**Addendum No. 3**  
Page 1 of 21

Joliet Junior College  
1215 Houbolt Road  
Joliet, IL 60431

**TO:** Prospective Respondents  
**SUBJECT:** Addendum No. 3  
**PROJECT NAME:** Renaissance Center Interior Renovations  
**JJC PROJECT NO.:** B16008

**SHEET NUMBER:**  
**S1.11**

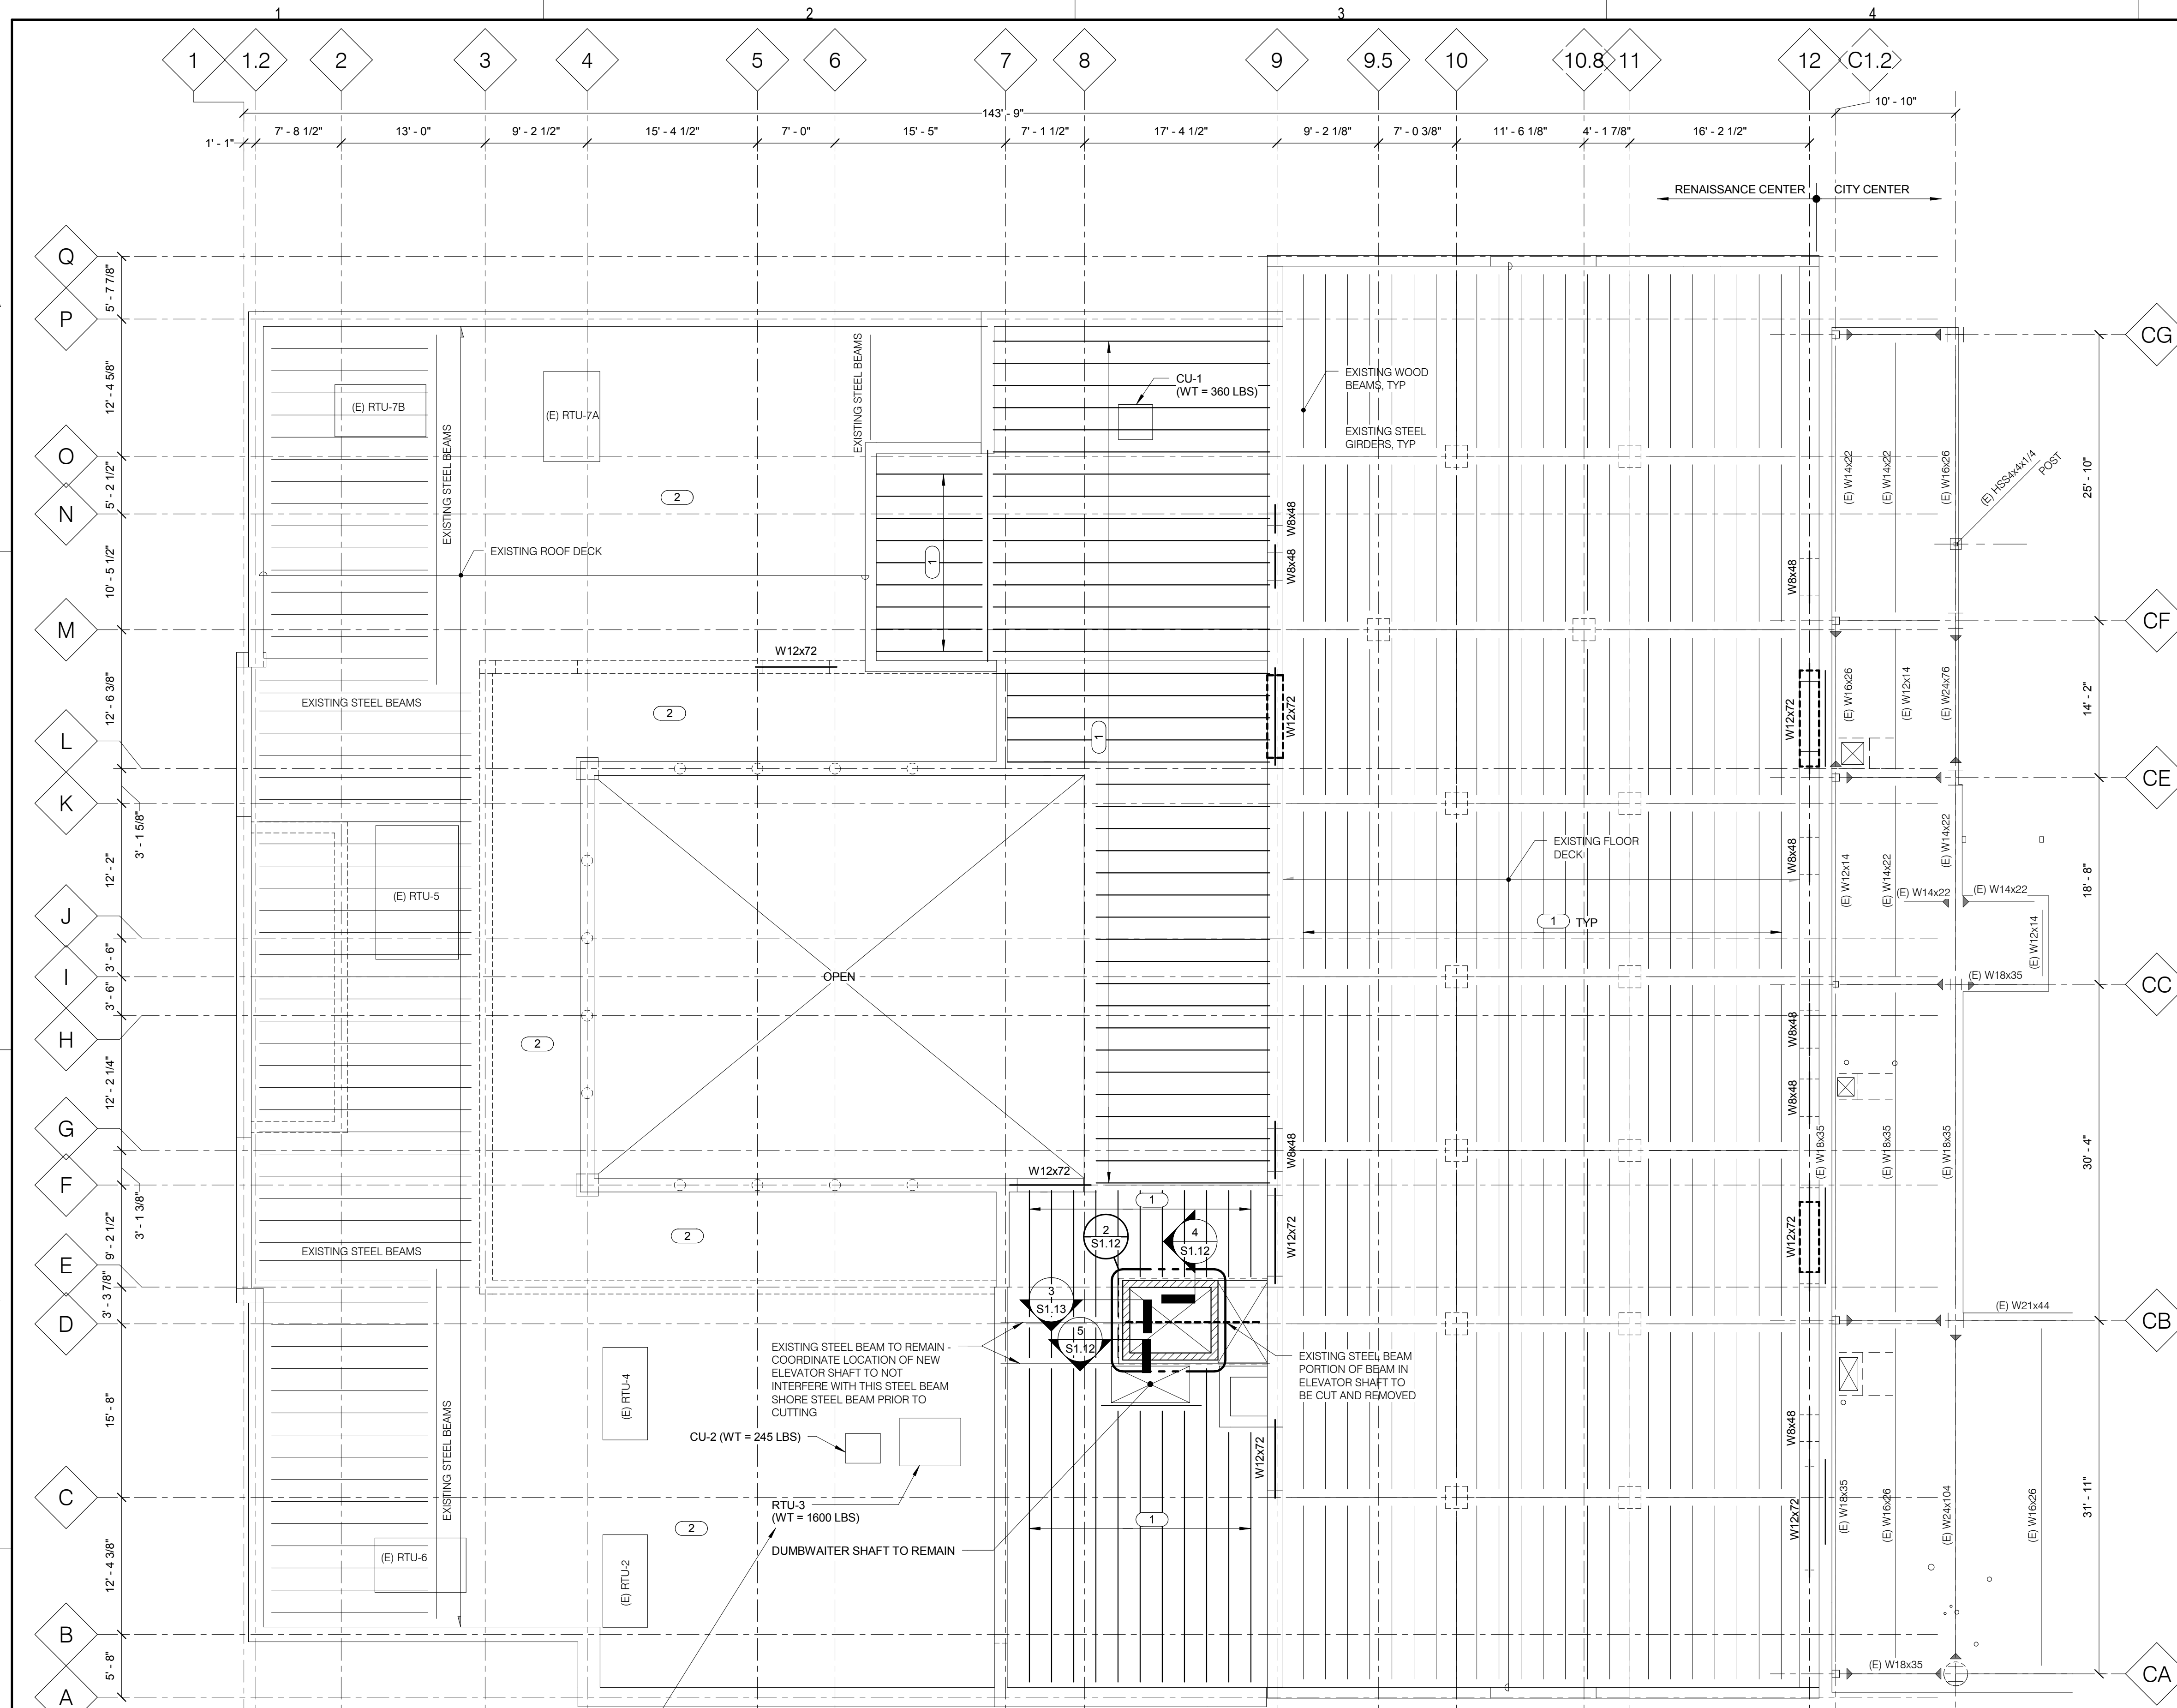
- A. Drawing S1.10: **Add** details 5 Thickened slab at Floor Sink and 6 Trench Drain Detail.
- B. Drawing S1.11: **Add** note about floor sink and trench drain coordination to Plan.
- C. Drawing S1.12: **Add** note about new RTU and CU locations to plan. **Add** note to Detail 3 about grouting below lintel bearing.

**M1.10**

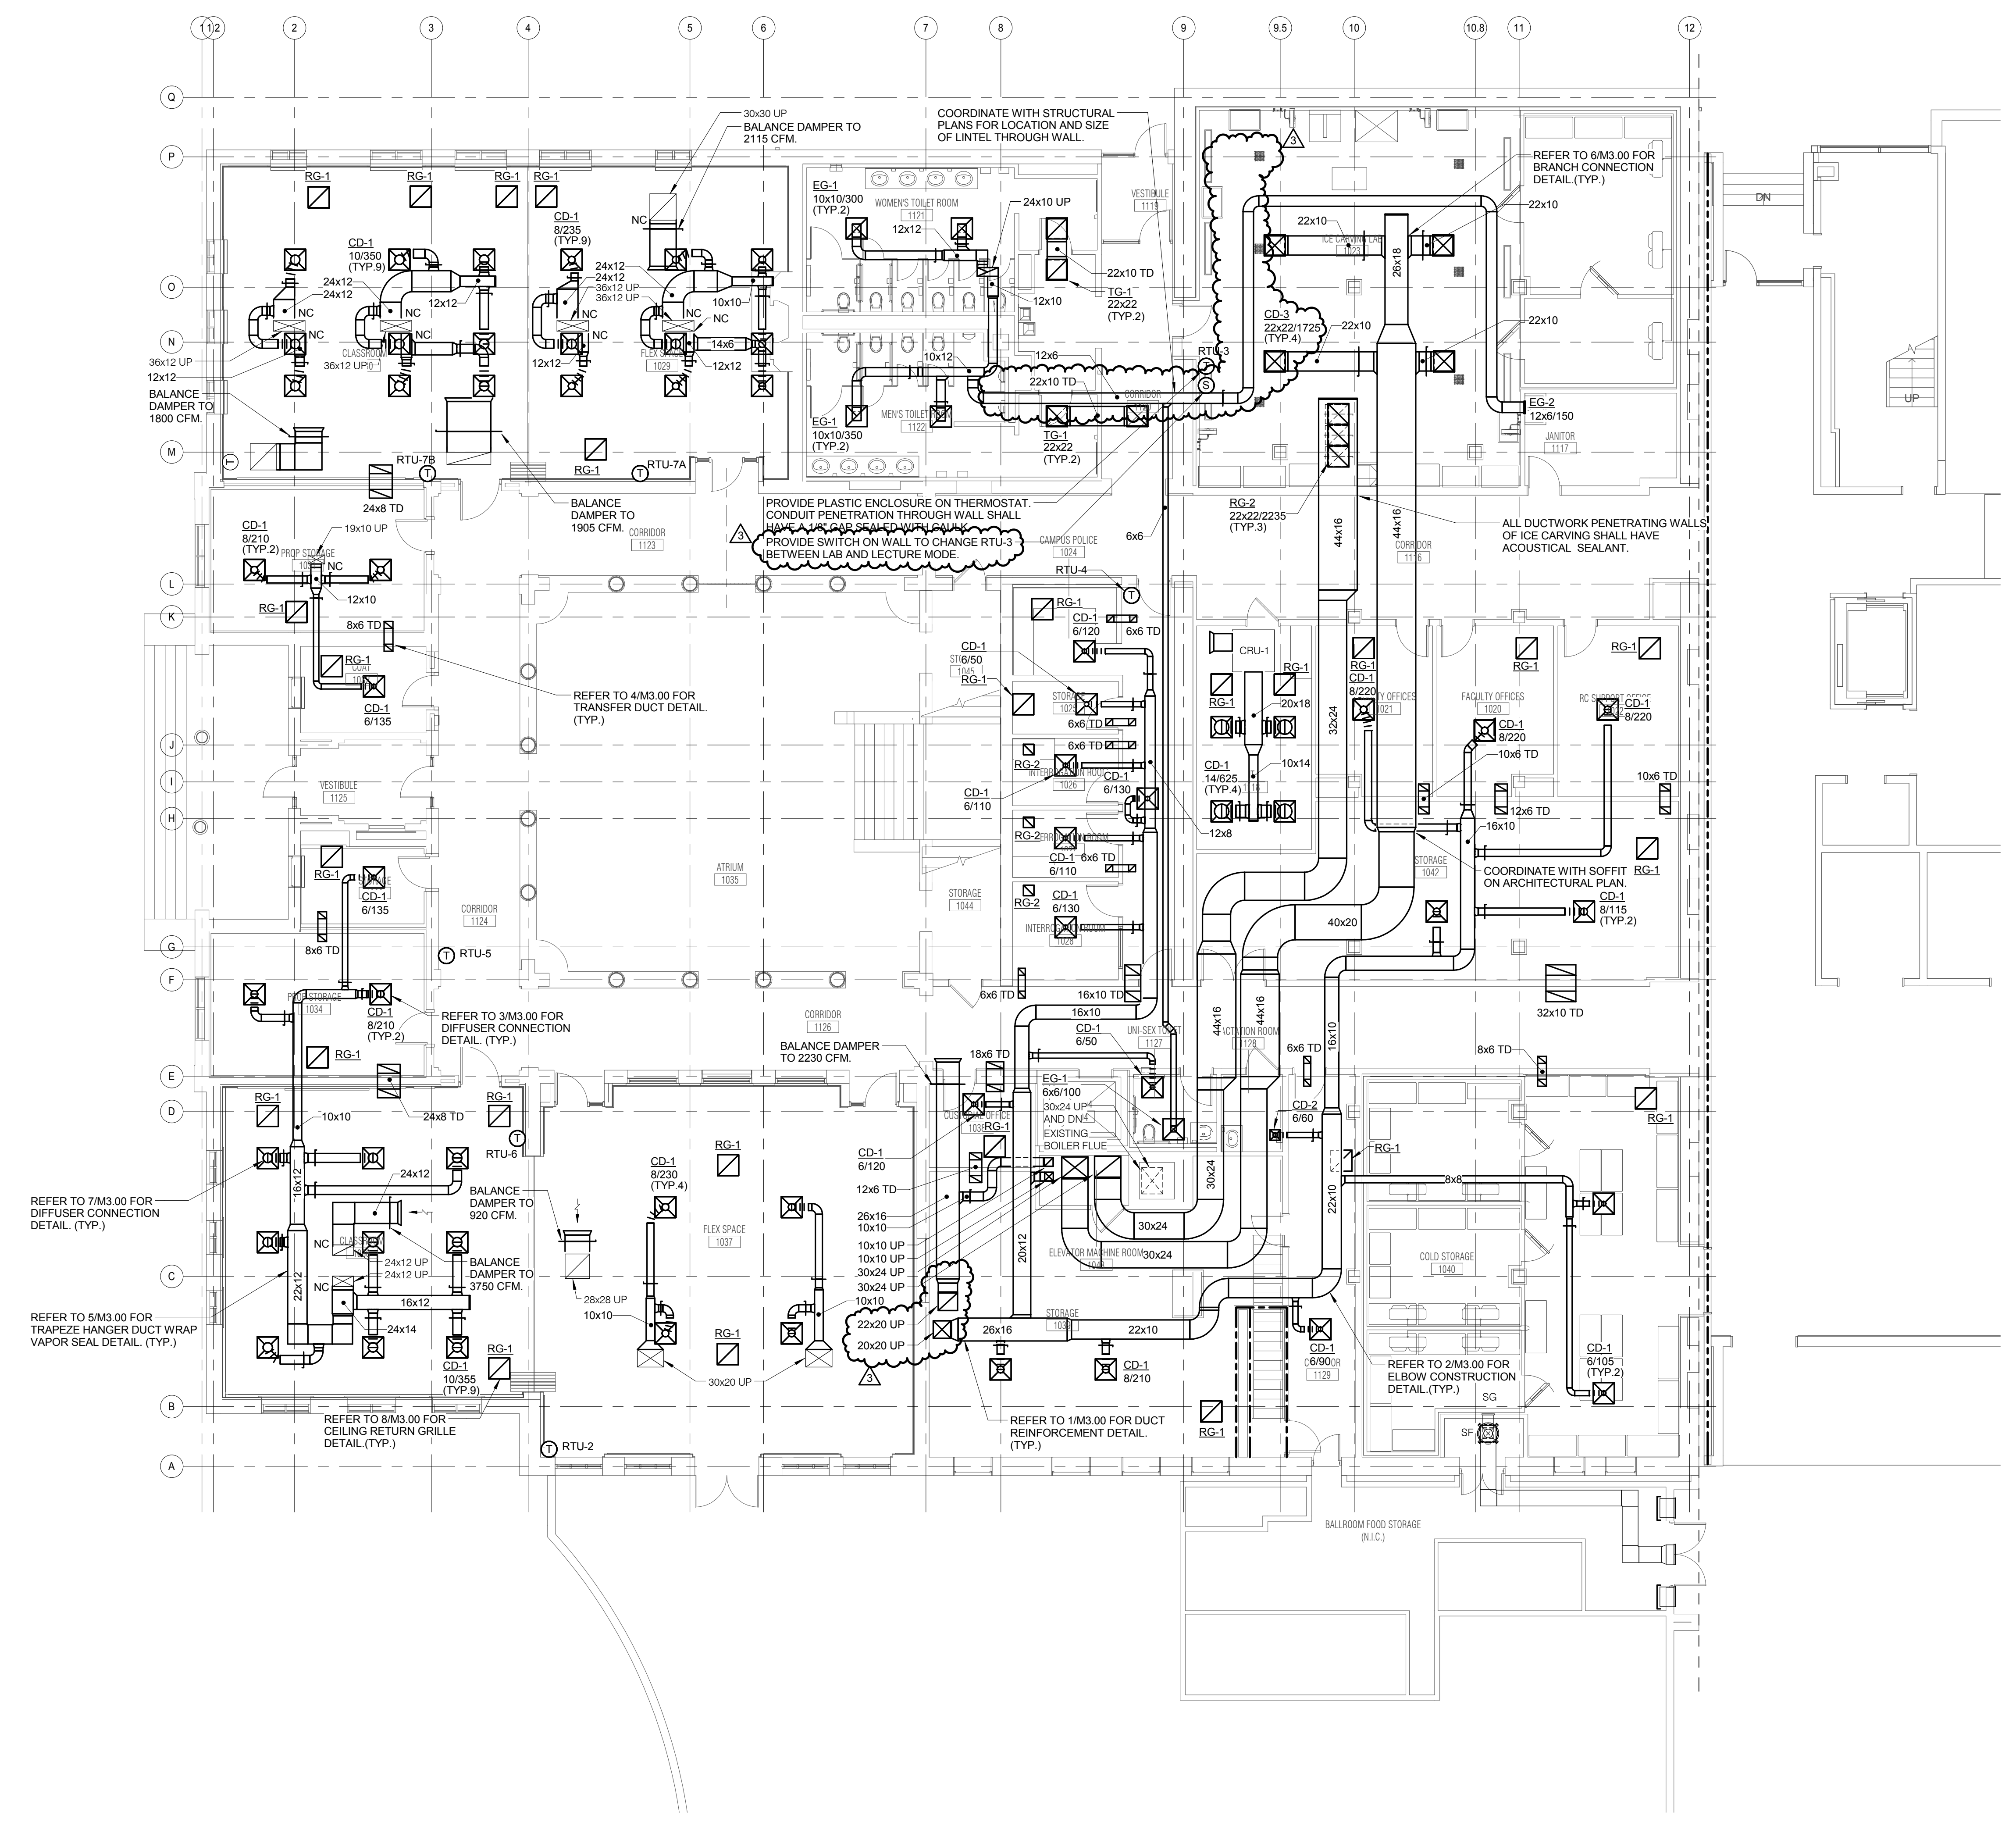
- B. Drawing M1.10: **Modify** return ductwork from RTU-4 to transition from 22x20 from floor above. **Remove** exhaust ductwork from Ice Carving lab 1023. **Modify** diffusers in Ice Carving Lab 1028 to CD-3. **Add** wall switch for RTU-3 mode. Refer to M1.10 for additional information.

SHEET NUMBER:  
**M1.20**

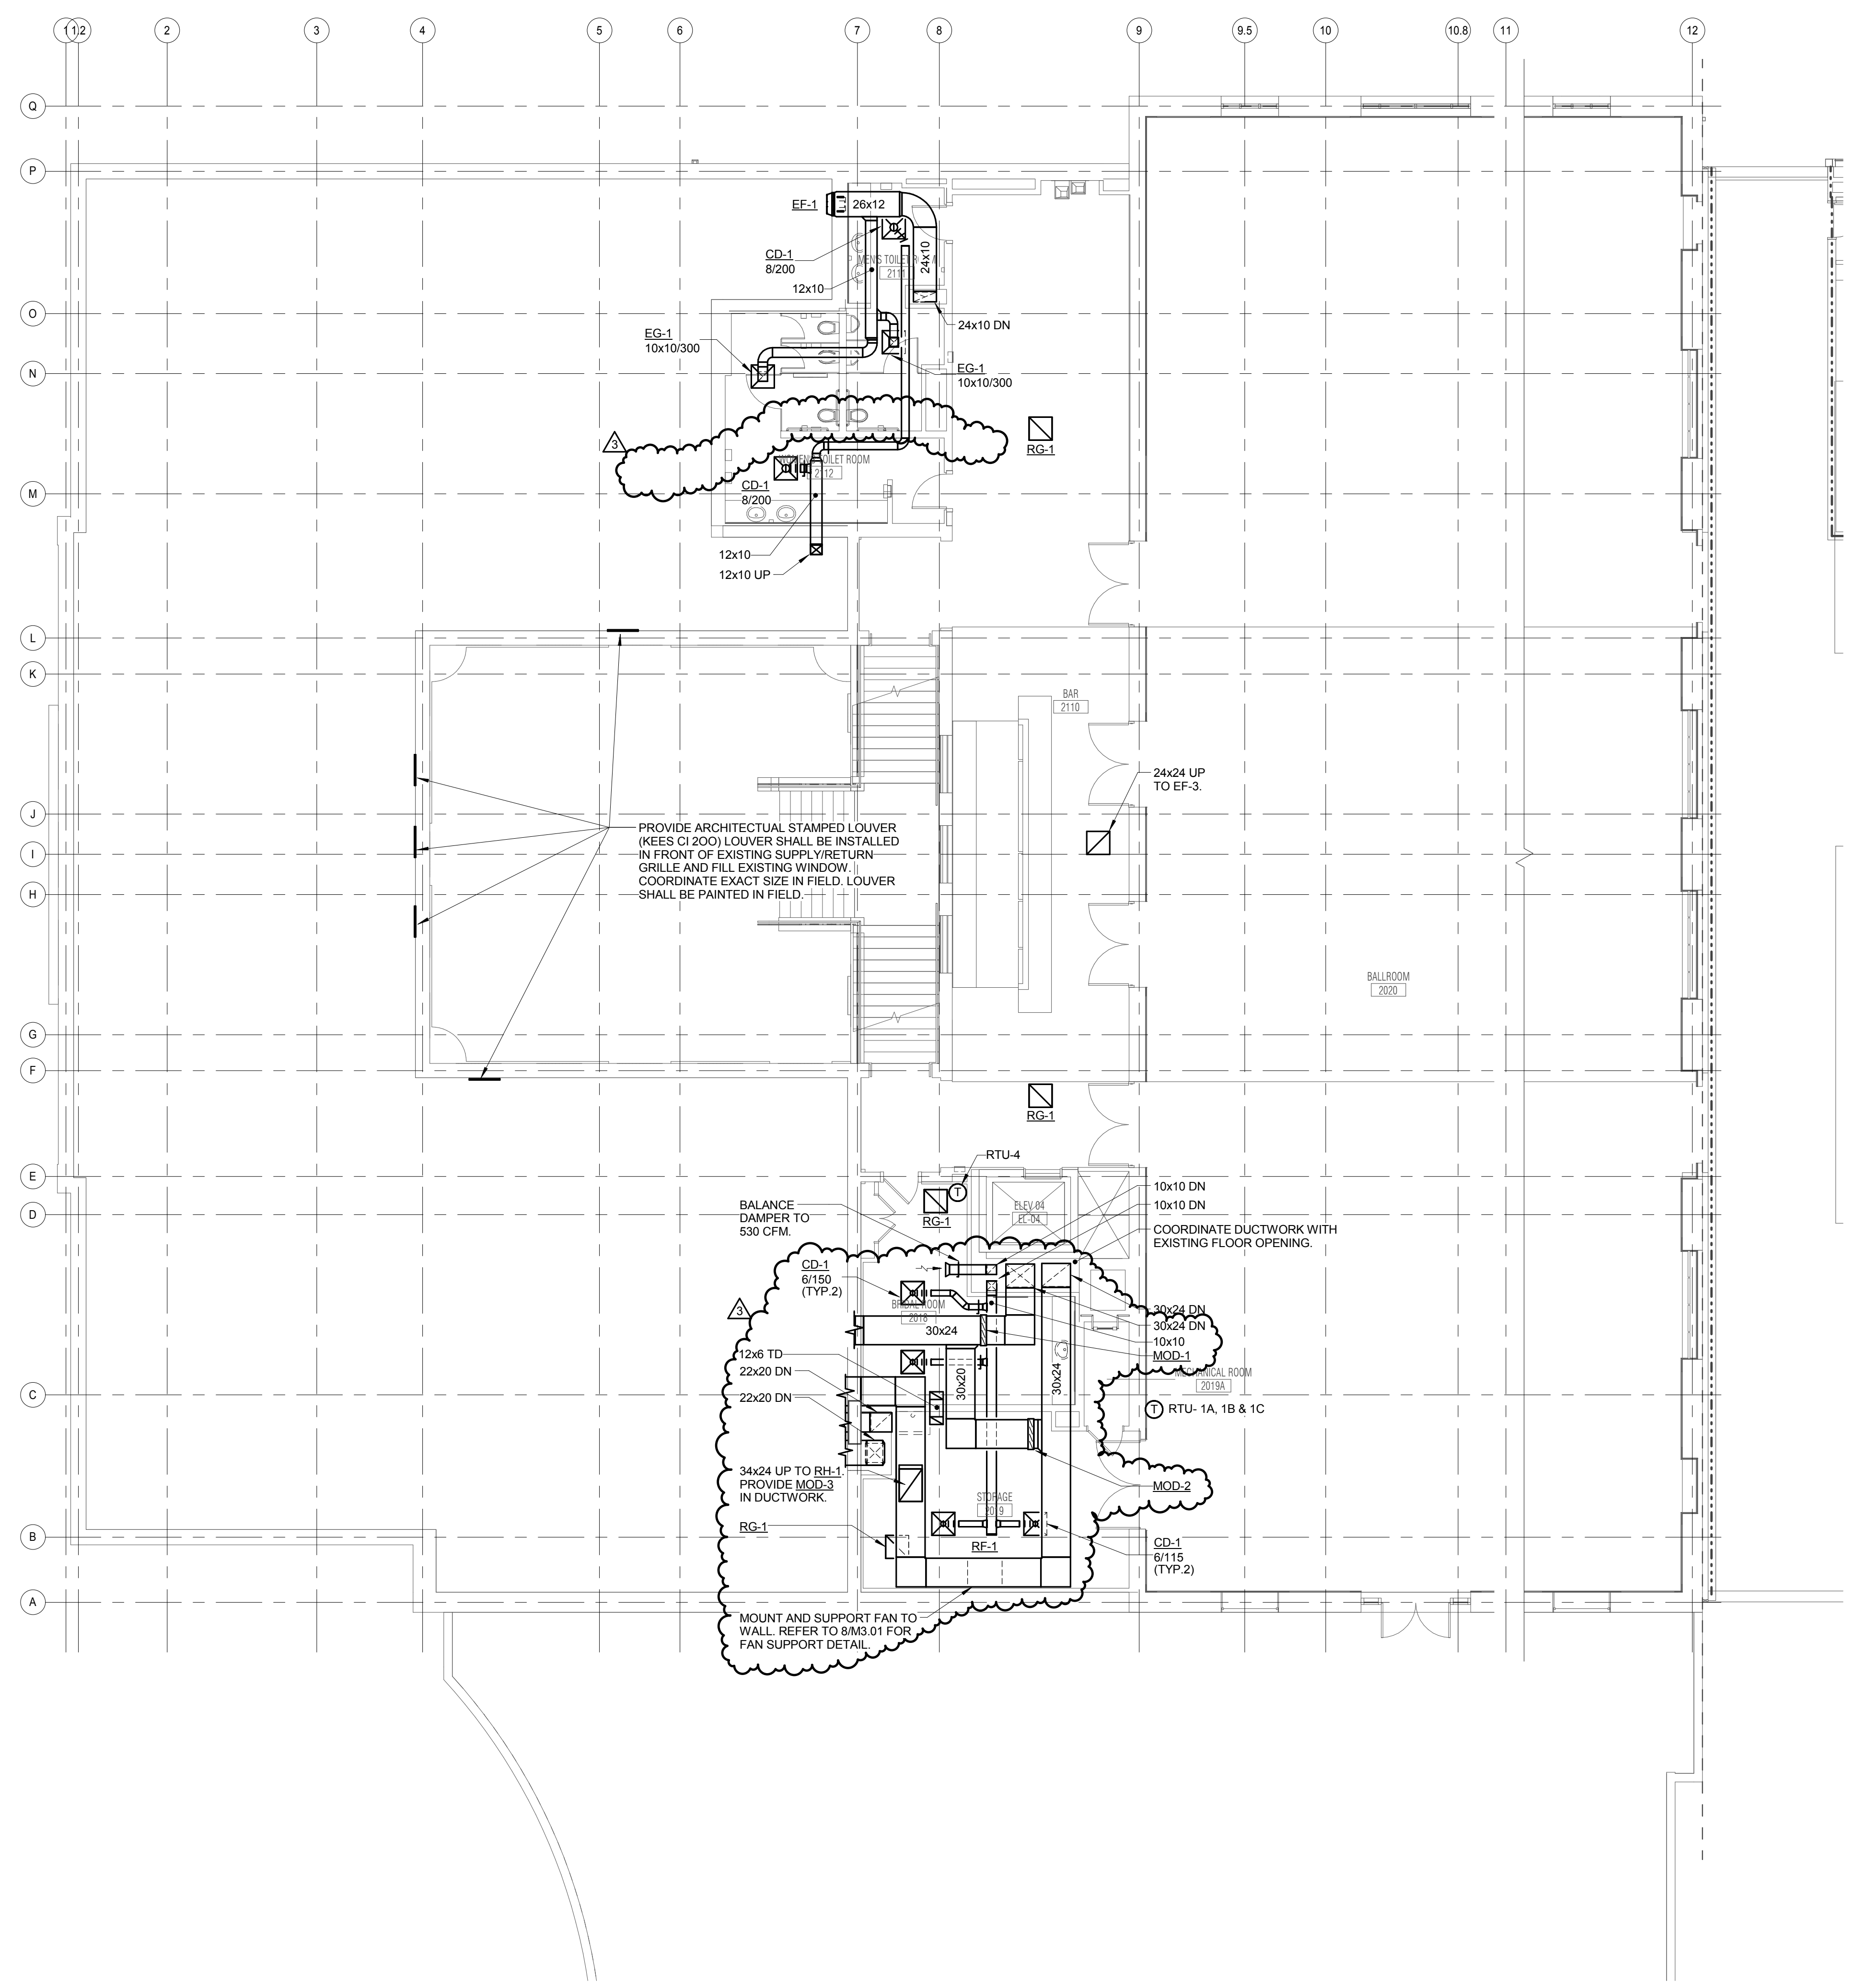
- C. Drawing M1.20: **Modify** return ductwork from RTU-4 to transition to 22x20. **Modify** ductwork from RTU-3 to run in ceiling space of Bridal Room 2018. **Add** MODs as shown on the drawings. **Remove** exhaust ductwork from Ice Carving lab 1023. **Add** RF-1 for RTU-3 return ductwork Refer to M1.20 for additional information.
